Section 4.55(1A) Modification Application
to SSD 8209-
Site 4A, Oakdale South Industrial Estate,
Kemps Creek

Statement of Environmental Effects
Site 4A, Oakdale South Industrial Estate, Kemps Creek

Project Name _____ **Costco Mod 1**

Figure 13: Proposed changes to office building, notated and clouded in red.

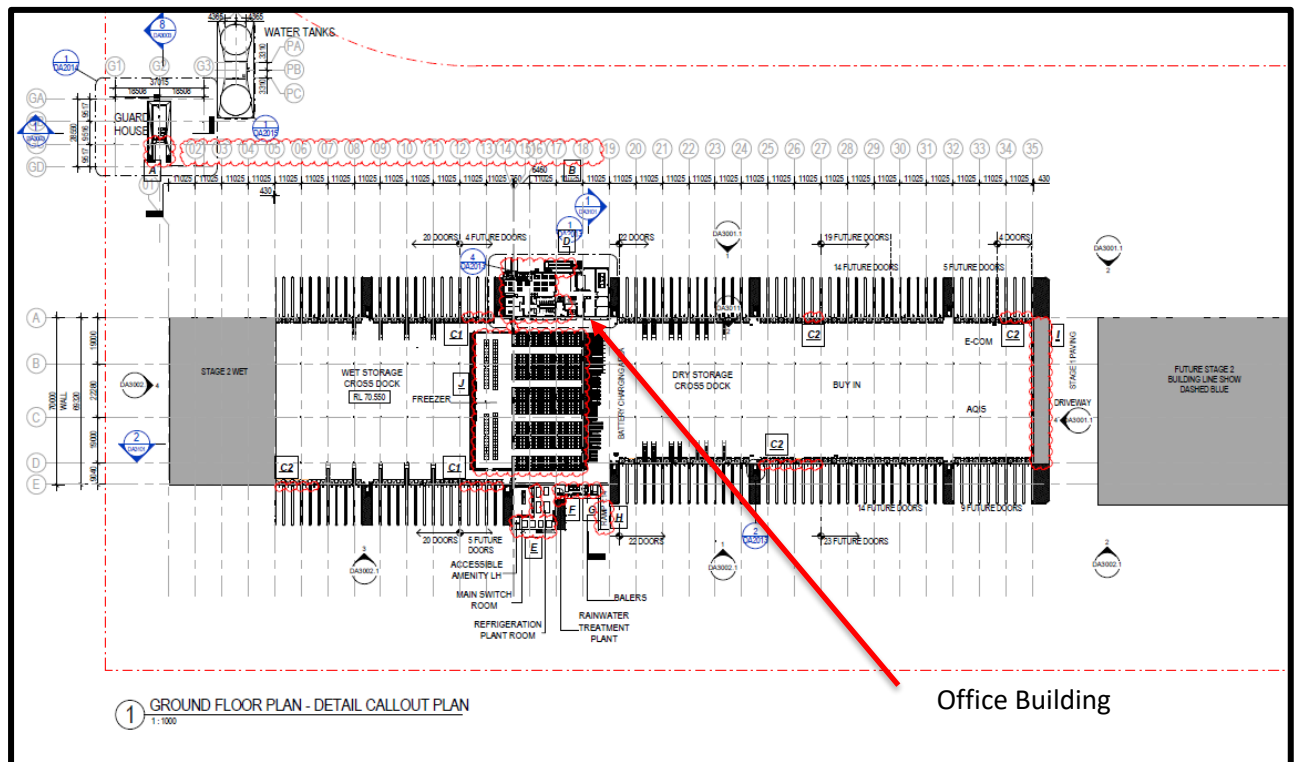
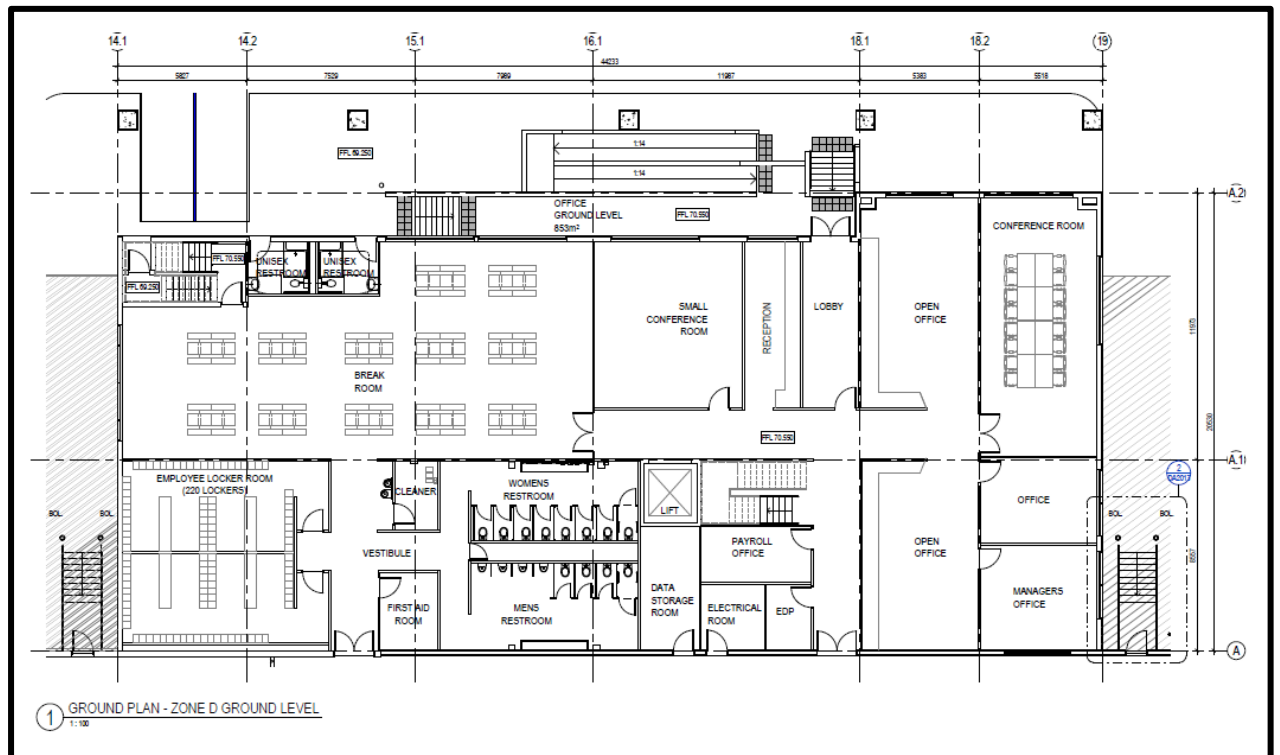
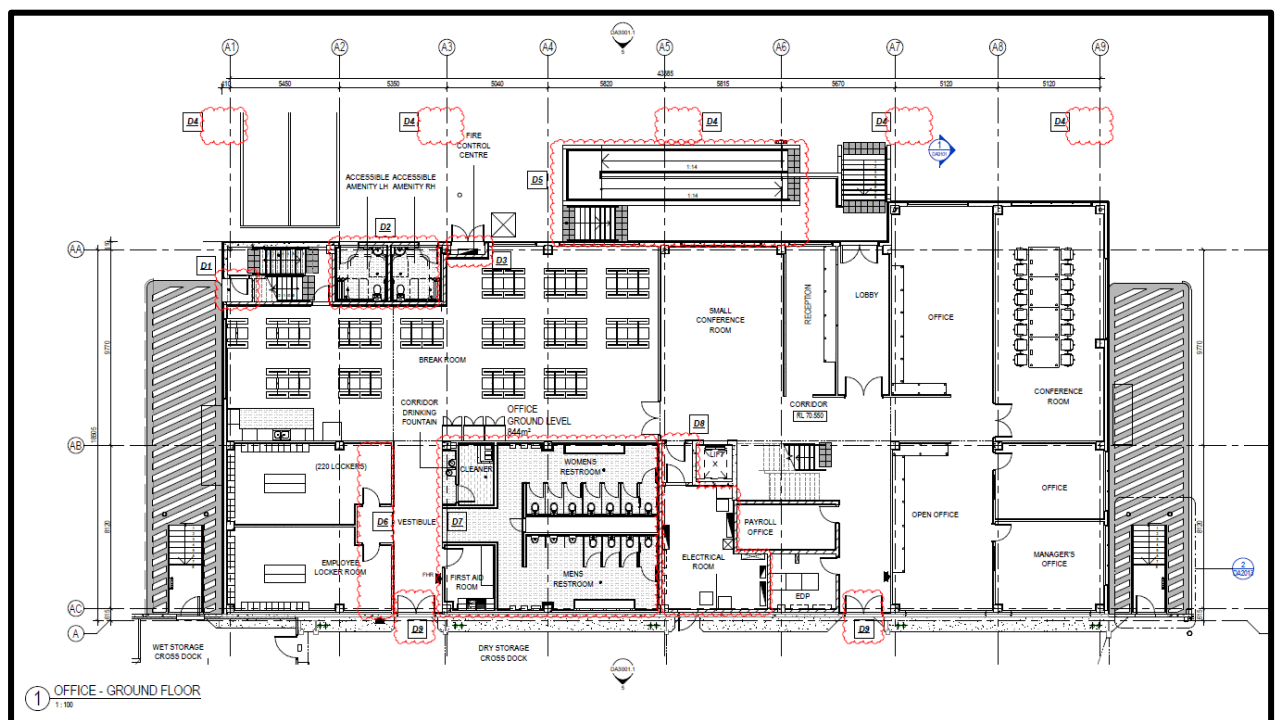
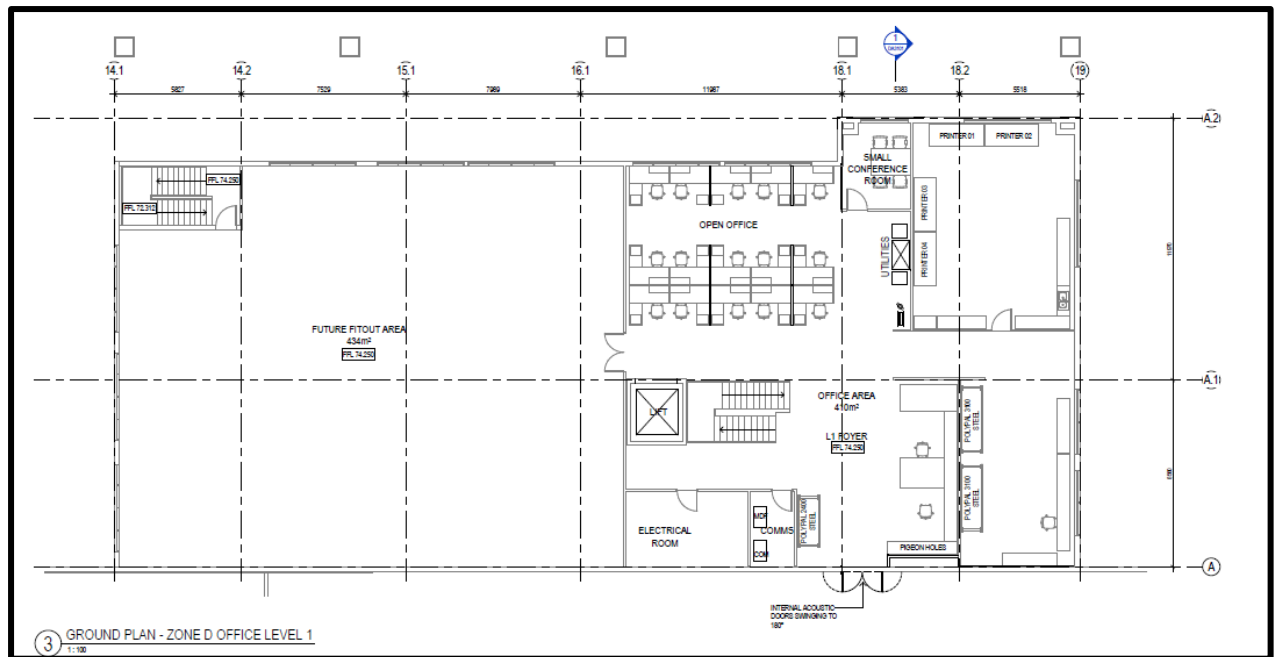
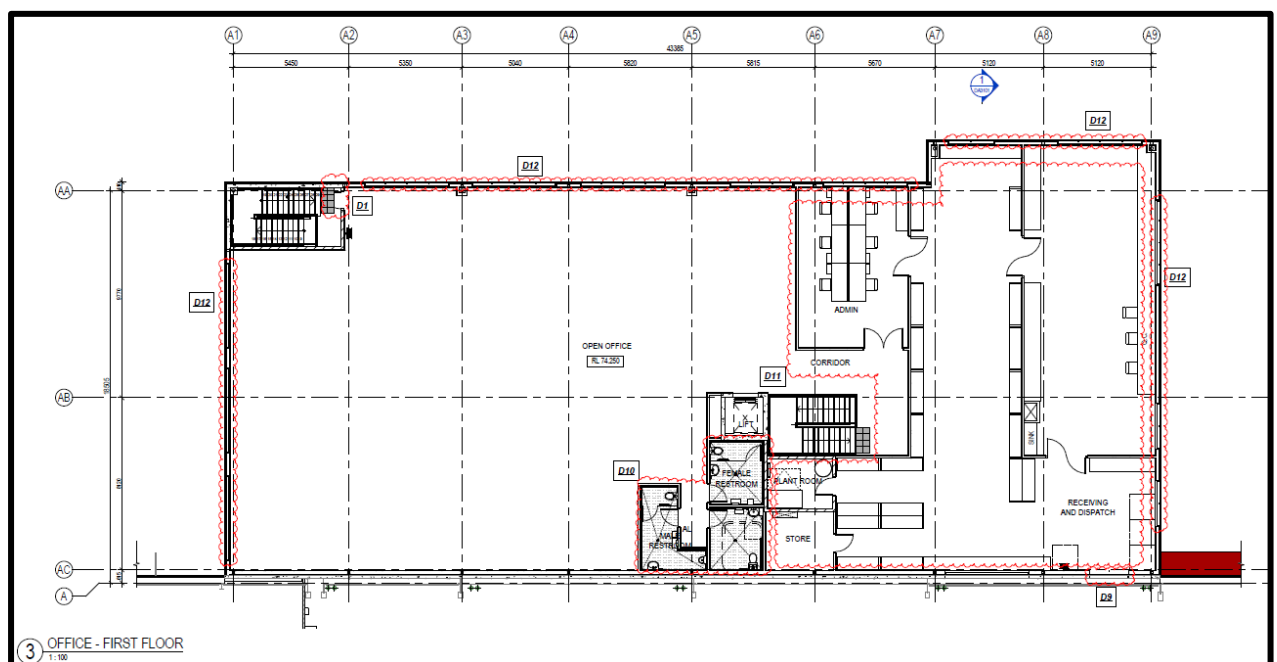
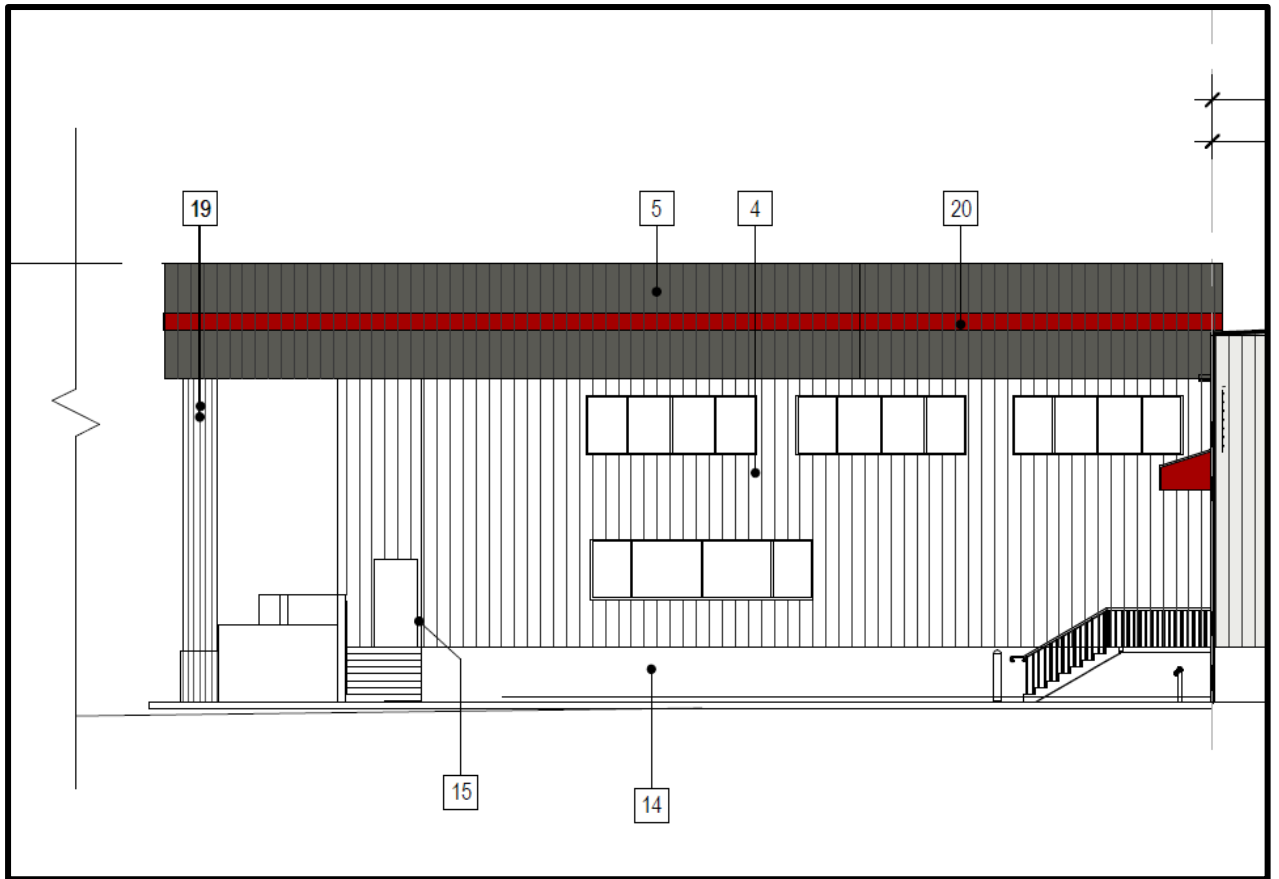
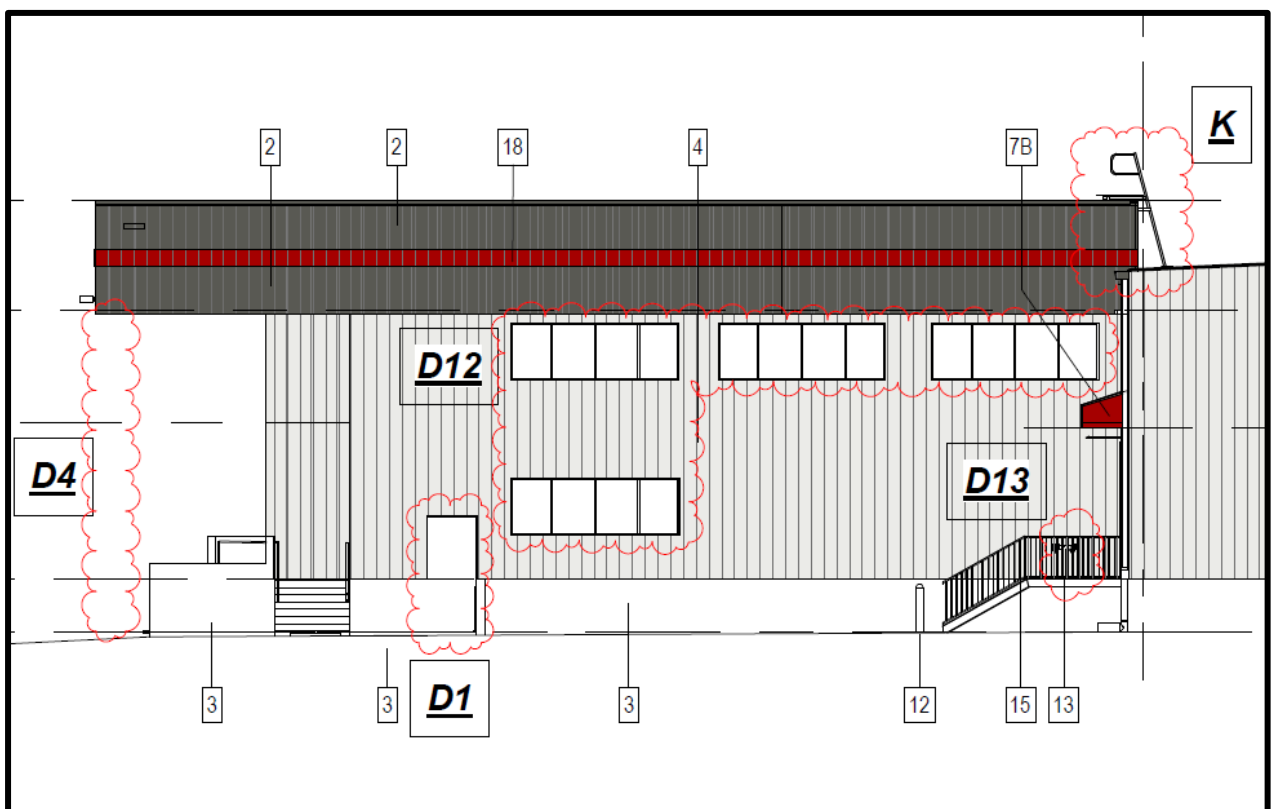
Changes to office building as denoted as **(D)** on architectural plans comprising of access ramp extensions, amenities, and changes to egress stair doors.

- i. Egress door reversed as referenced as **(D1)** on architectural plans;
- ii. Accessible amenities rotated as referenced as **(D2)** on architectural plans;

- iii. Provision of a fire control centre cupboard added to western elevation as referenced as **(D3)** on architectural plans;
- iv. Deletion of external columns to the entry awning along western elevation and 450mm awning extension to each side of the office as referenced as **(D4)** on architectural plans;

- v. Western elevation ramp extended with adjoining stairs realigned accordingly as referenced as **(D5)** on architectural plans;
- vi. Reduction of employee locker room by 8.57m² as referenced as **(D6)** on architectural plans;

- vii. Relocation of amenities, cleaner and first aid room to suit reduced employee locker room as referenced as **(D7)** on architectural plans;
- viii. Provision of one WC and cubicle added in lieu of one urinal in men's restroom as referenced as **(D7)** on architectural plans;

- ix. Provision of a second egress to the electrical room between lift and women's restroom wall and reconfigured electrical room layout as referenced as **(D8)** on architectural plans;

- x. Entry/egress door relocated accordingly from the office to the depot to as referenced as **(D9)** on architectural plans;
- xi. Provision of Amenities added to level 1 along eastern elevation as referenced as **(D10)** on architectural plans;

- xii. Reconfiguration of level 1 internal office layout as referenced as **(D11)** on architectural plans. No increase to first floor GFA proposed;
- xiii. Changes to external windows to level 1 along northern, western and southern elevation as referenced as **(D12)** on architectural plans;

- xiv. Relocation of external hydrants from ground level to top of external (northern) stair case as referenced as **(D13)** on architectural plans;

Figure 21: Proposed changes to condenser platform level and plant room elevations as notated and clouded in red.

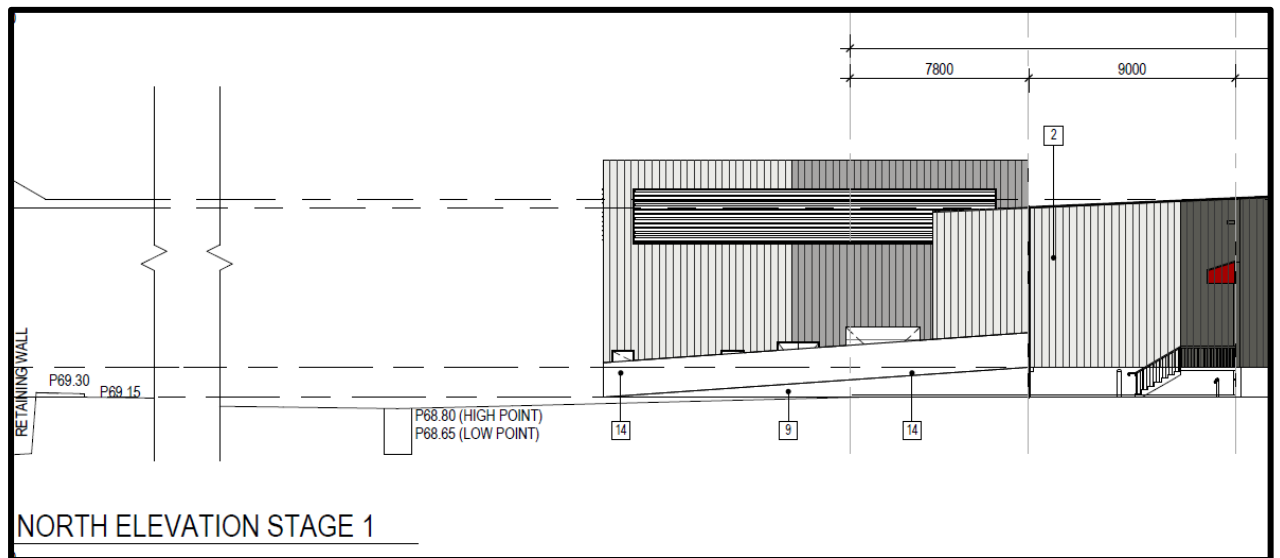
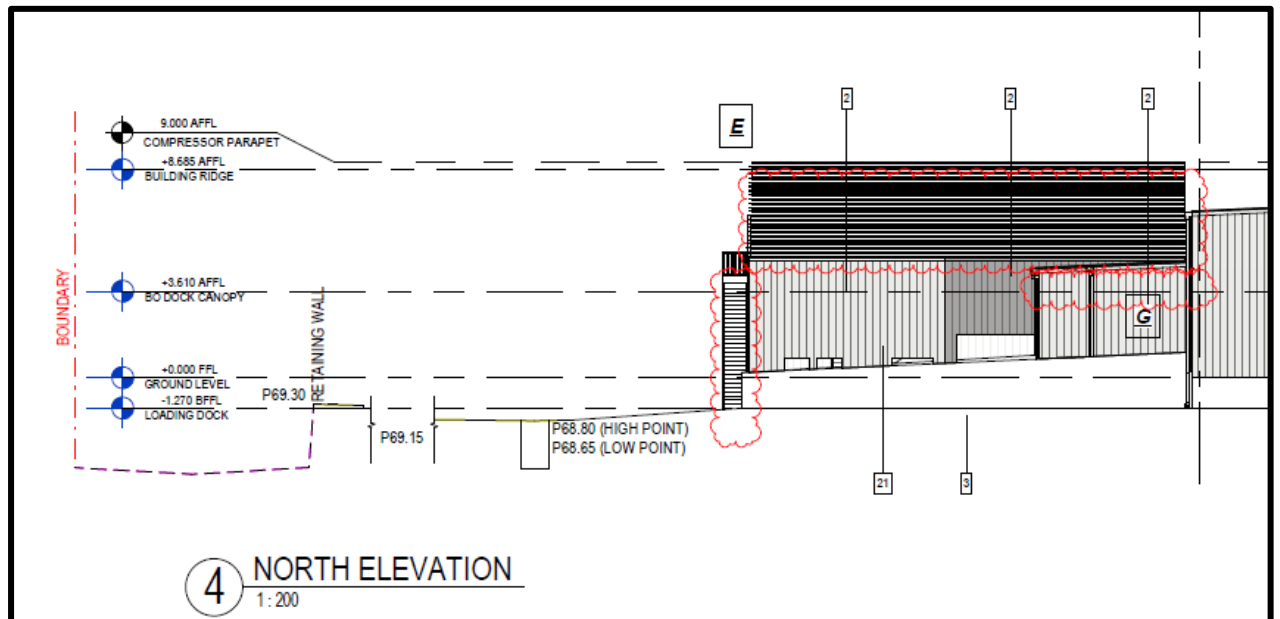
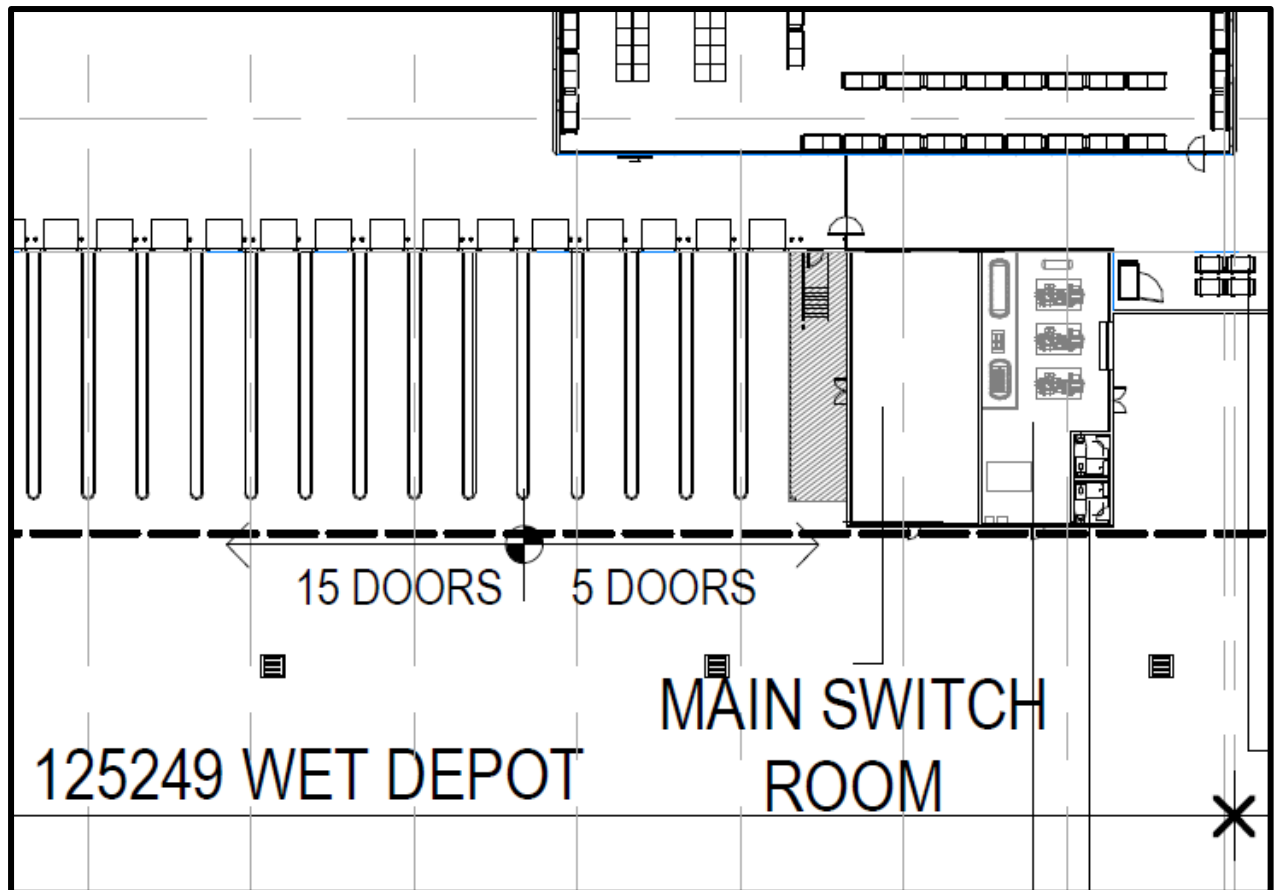
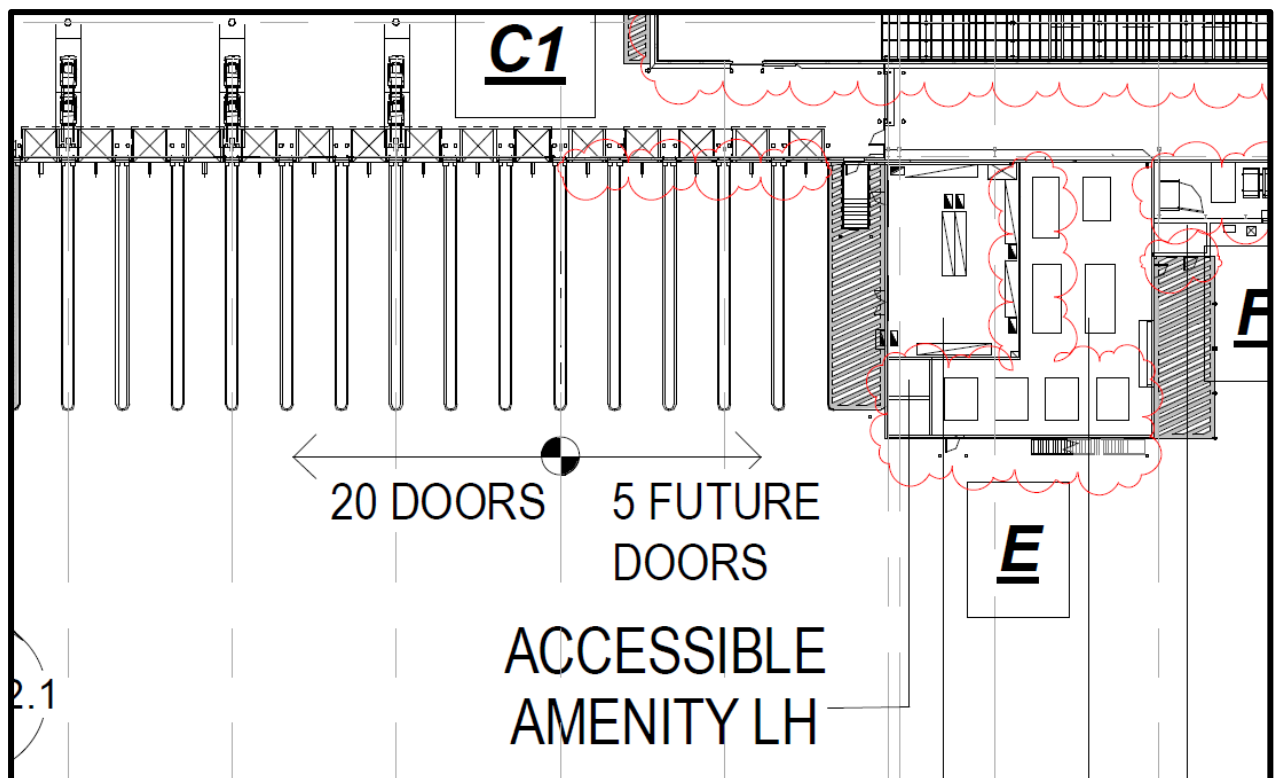
Changes to Plant room layout, depot ground level amenities along eastern elevation and changes to louvre screens around condenser platform level as denoted as **(E)** on architectural plans.

- i. Reconfiguration of plant room layout and amenities relocated;
- ii. External stair case added to the condenser platform to eastern elevation;
- iii. Changes to approved solid and louvre screen around condenser platform to continuous louvre screen, located centrally along the eastern elevation.
